SUBMITTAL IDENTIFICATION SHEET

WEBSTER UNIVERSITY ISB
PROJECT NAME

05 5000-010 REV002
CANNON DESIGN SUBMITTAL NUMBER

ML-4202-A
Alternating Tread Stair

195.000 inch 68 Degree Carbon Steel, Gray Primer with Optional Straight Handrail

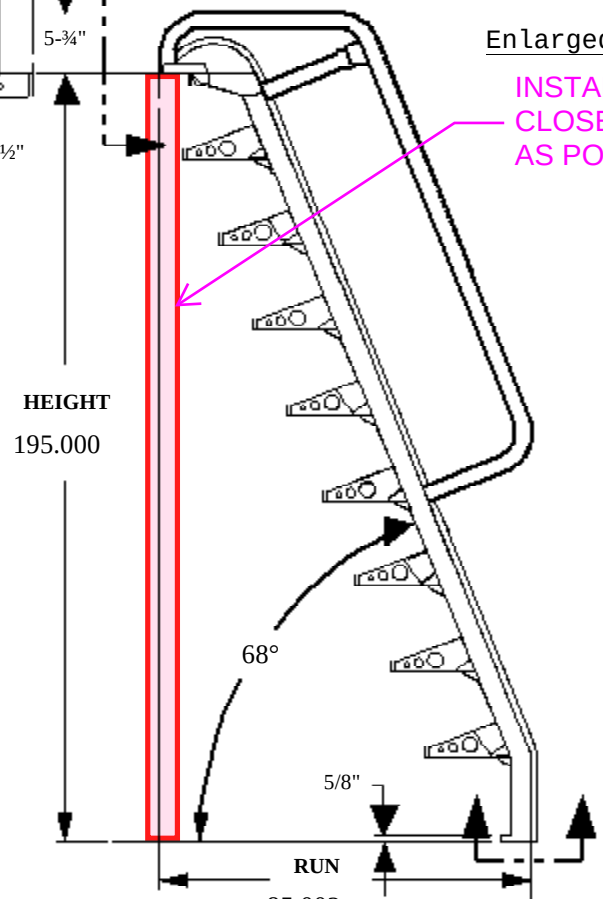
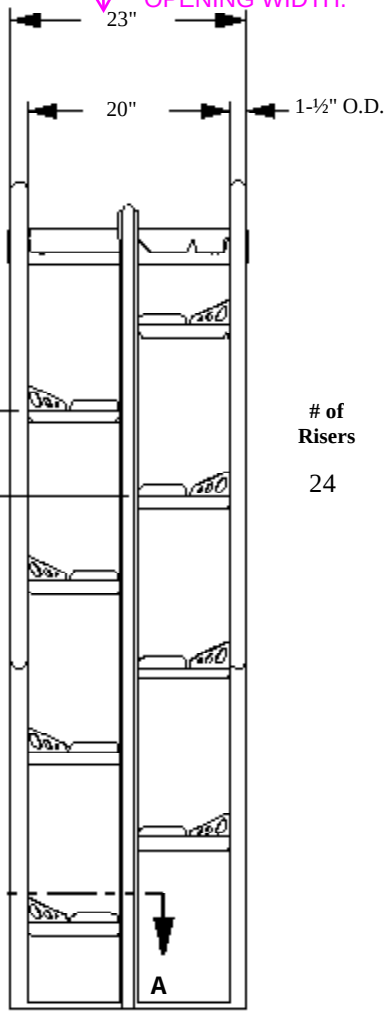
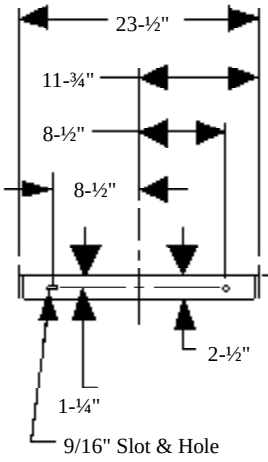
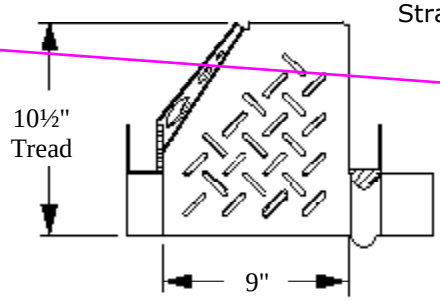
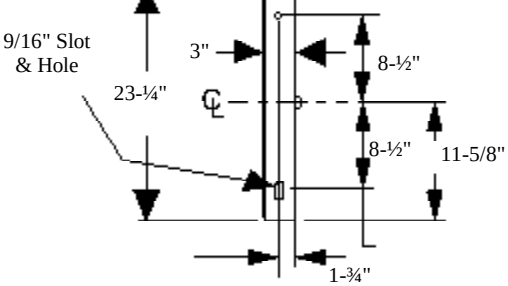
GC to coordinate with location of roof hatch.

Move the east wall with door to east as close to the stand pipe as possible considering the required clearances at standpipe. Revise the stair railing at the location accordingly.

REVISED TO 16'-3" HEIGHT
(LEVEL 4 TO CALCULATED T/ROOF)
AND SUBMITTED FOR RE-APPROVAL.

~ BOTTOM TREAD WILL BE ON
RIGHT-HAND SIDE.

GC TO COORDINATE STAIR WIDTH REQUIREMENTS WITH ROOF HATCH OPENING WIDTH.

INSTALL STAIR AS CLOSE TO THE WALL AS POSSIBLE

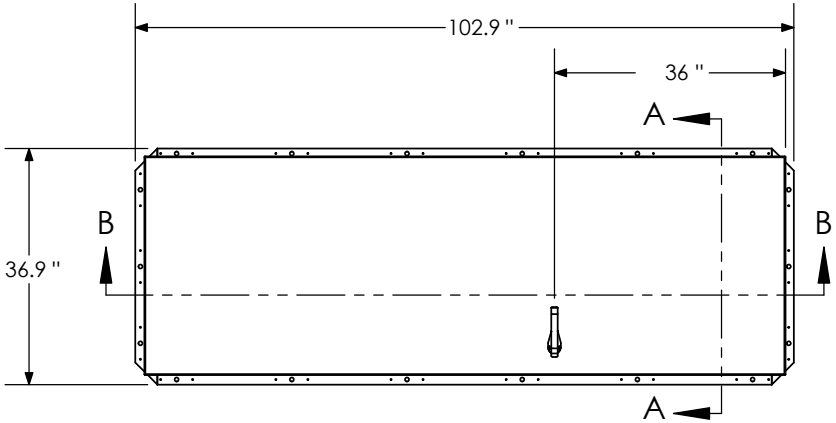
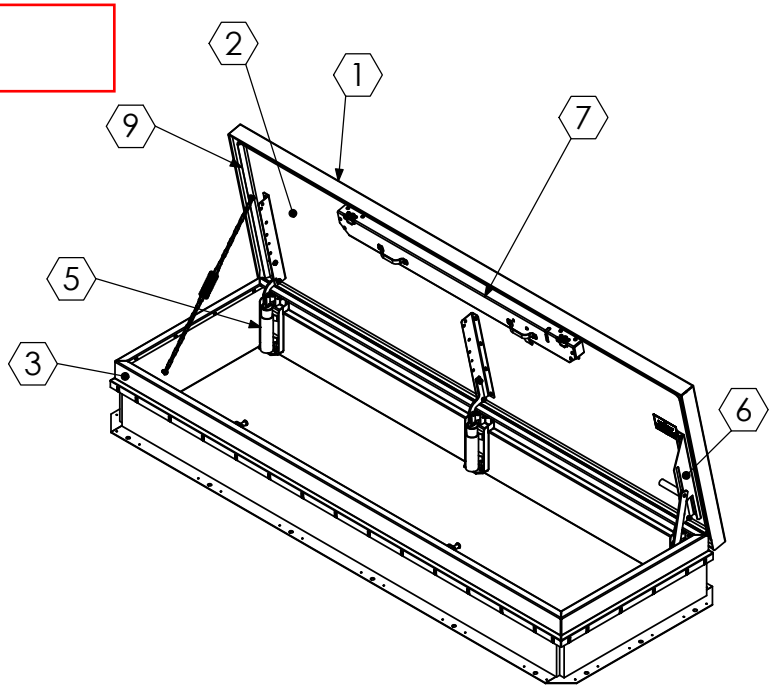
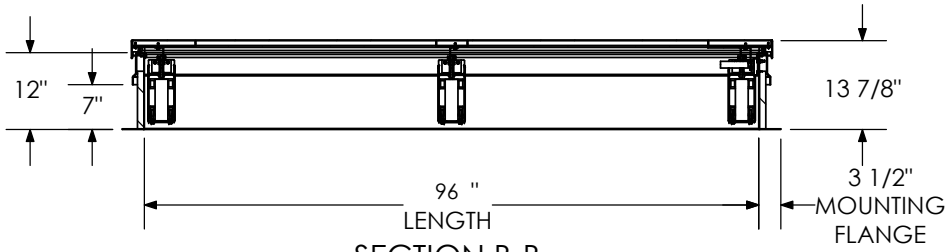
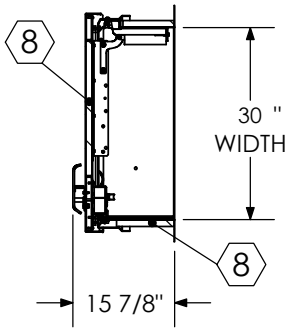
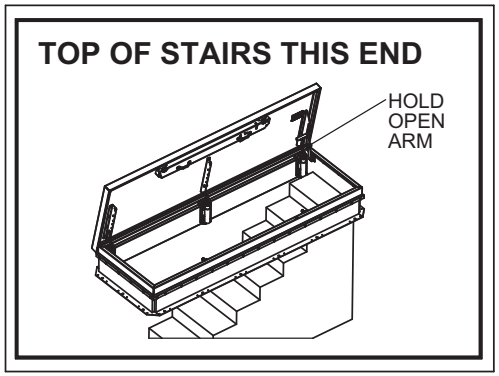
ROOF HATCH INCLUDED FOR COORDINATION ONLY.
